Technical Bulletin

No: TCM-0028-B
Page 1 of 1

Issue Seal holes in Cavity Bottom when replacing Lower Antenna Motor or Oven Tray

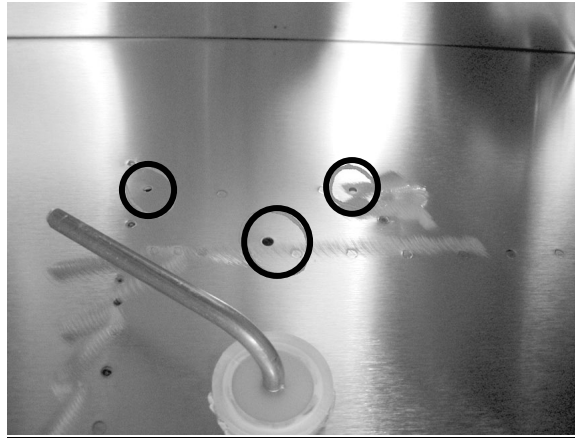
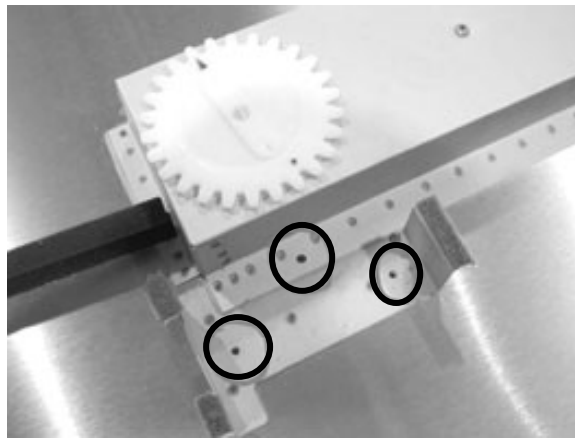
Action If replacing the Lower Antenna Motor or Oven Tray on these models, seal the three holes shown below with RTV sealant at the same time.

Analysis of failed lower antenna motors has indicated some failures may be caused by grease dripping through these holes and on to the motor.
